STAFF REPORT
COMMUNITY DEVELOPMENT DEPARTMENT

HEARING DATE: 5/23/2023
TO: Mayor & City Council
FROM: Sonya Allen, Associate Planner
208-884-5533
SUBJECT: H-2022-0013
Promenade Cottages Subdivision
LOCATION: 403 E. Fairview Ave., in the NW 1/4 of
Section 7, Township 3N, Range 1E.
(Parcel #S1107212707)

B. Preliminary Plat (dated: 4/7/2023)

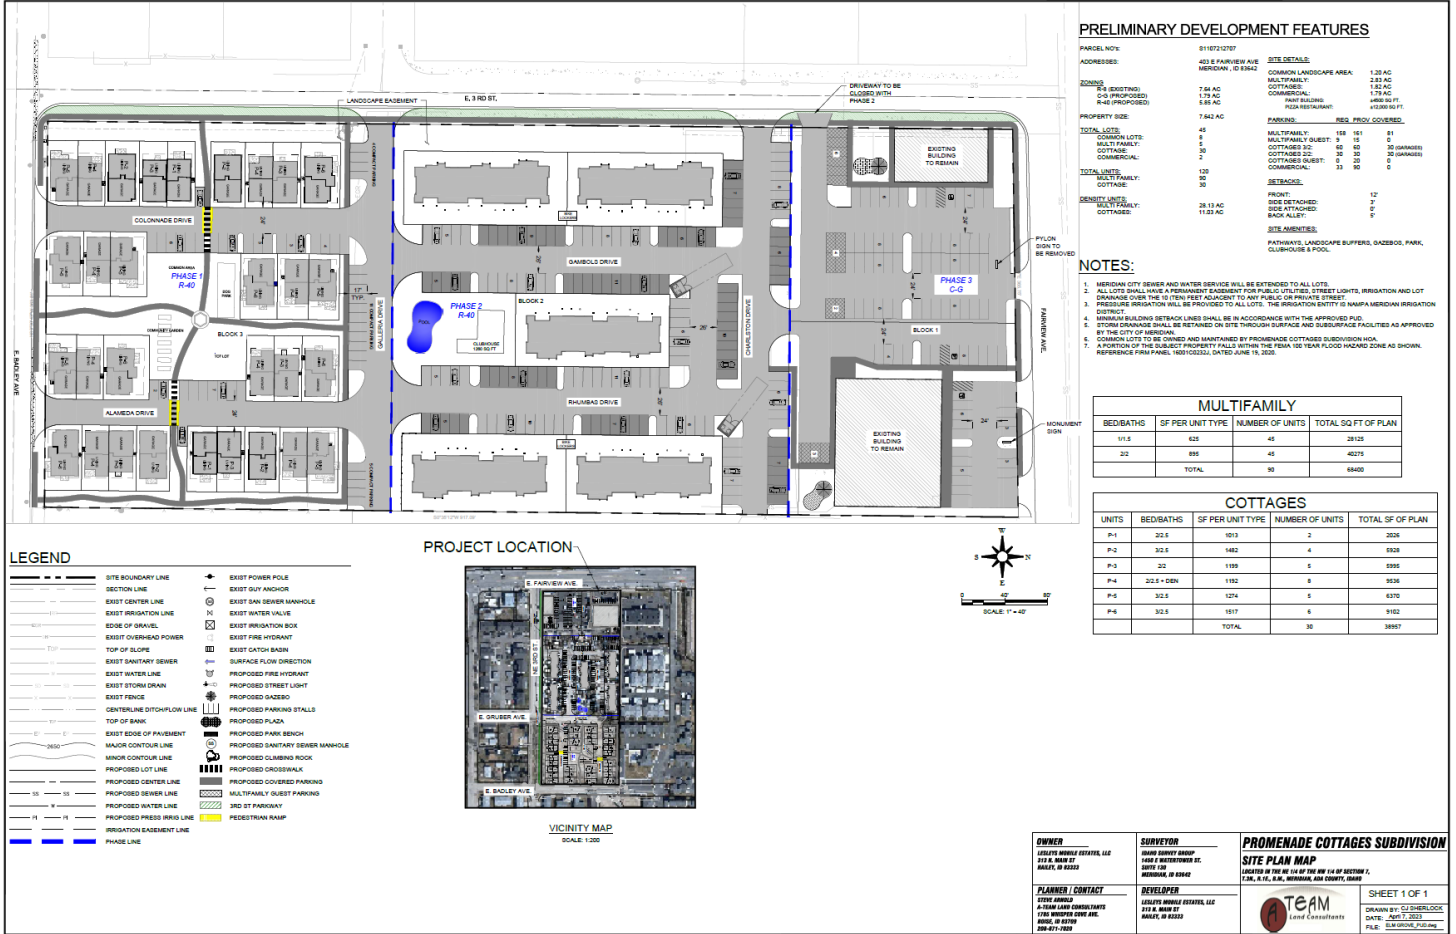
There are existing trees on this site that are proposed to be removed with development. Mitigation is required in accord with the standards listed in UDC [11-3B-10C.5](#). **Mitigation information should be included on the landscape plan in accord with UDC standards.**

All fencing is required to comply with the standards listed in UDC 11-3A-7. No fencing is depicted on the landscape plan. However, the Applicant intends to construct 6-foot tall solid vinyl fencing along the eastern and northern boundaries of the residential portion of the development to screen the residential from the commercial uses. Fencing details should be included on the landscape plan submitted with the final plat application(s).

- f. Delineate the privates from parking areas on the common lot.
- 2.2 The landscape plan included in Section VII.C shall be revised as follows:
- a. Depict a 25-foot wide street buffer along E. Fairview Ave., an arterial street, and a 20-foot wide street buffer along NE 3rd St., to be improved as a collector street, with landscaping in accord with the standards listed in UDC [11-3B-7C](#).

- b. Landscaping is required adjacent to all pathways within the site in accord with the standards listed in UDC [11-3B-12C](#).
 - c. Mitigation information should be included on the landscape plan for all existing trees that are being removed with development in accord with the standards listed in UDC [11-3B-10C.5](#).

- d. Depict a minimum 5-foot wide detached sidewalk with an 8-foot wide parkway along the east side of NW 3rd Street in accord with the Downtown Meridian Street Cross-Section Master Plan (see pg. 4-11).

- f. Remove the pedestrian pathway along the eastern boundary of the single-family portion of the site at the direction of the Commission.
- 2.3 Future development shall be consistent with the minimum dimensional standards listed in UDC [Table 11-2A-8](#) for the R-40 zoning district and UDC [Table 11-2B-3](#) for the C-G zoning district.

D. Site Plan (dated: 4/7/2023)

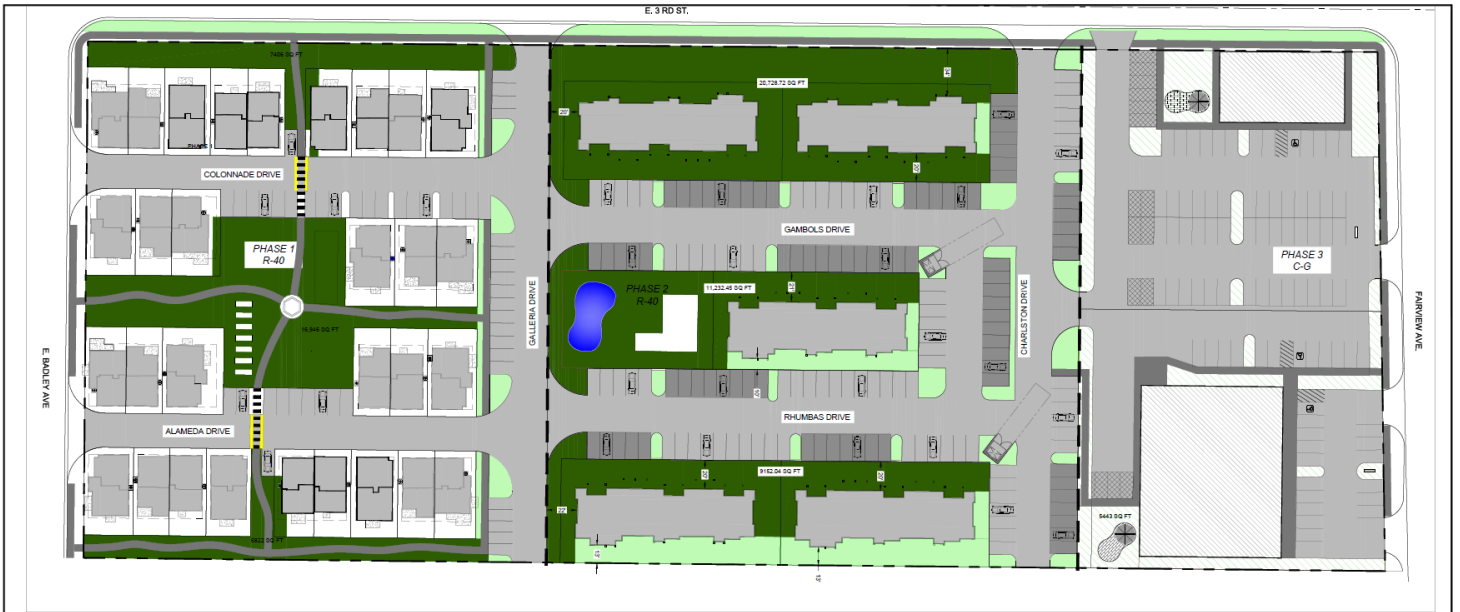
Based on the number of vehicle parking spaces proposed (i.e. 176), a minimum of seven (7) bicycle parking spaces are required per UDC [11-3C-6G](#) that comply with the standards listed in UDC [11-3C-5C](#). Bike racks should be provided in central locations for each multi-family building and the amenity building. Bicycle parking should be included on the site plan in accord with these standards.

*Based on 90 multi-family units, a minimum of four (4) amenities are required with at least one from each category listed in UDC [11-4-3-27D.1](#). The site plan depicts the following amenities: a swimming pool, clubhouse, dog park, community garden, bike lockers and a tot lot from the quality of life, open space and recreation categories. **An additional amenity should be provided from the multi-modal category.***

- b. Remove the western-most driveway access driveway via E. Fairview Ave. on the commercial portion of the property as it does not meet ACHD policy.
 - c. Remove one of the two driveway accesses via E. Fairview Ave. in front of the existing multi-tenant building in accord with UDC [11-3A-3](#), unless otherwise waived by City Council.

- 3.2 The site/landscape plans submitted with the Certificate of Zoning Compliance shall be revised as follows:
 - a. All on-site service areas, outdoor storage areas, waste storage, disposal facilities, and transformer and utility vaults shall be located in an area not visible from a public street, or shall be fully screened from view from a public street in accord with UDC [11-4-3-27B.2](#).

- b. Depict the location of the property management office; maintenance storage area; central mailbox location, including provisions for parcel mail, that provide safe pedestrian and/or vehicular access; and a directory and map of the development at an entrance or convenient location for those entering the development in accord with UDC [11-4-3-27B.7](#).
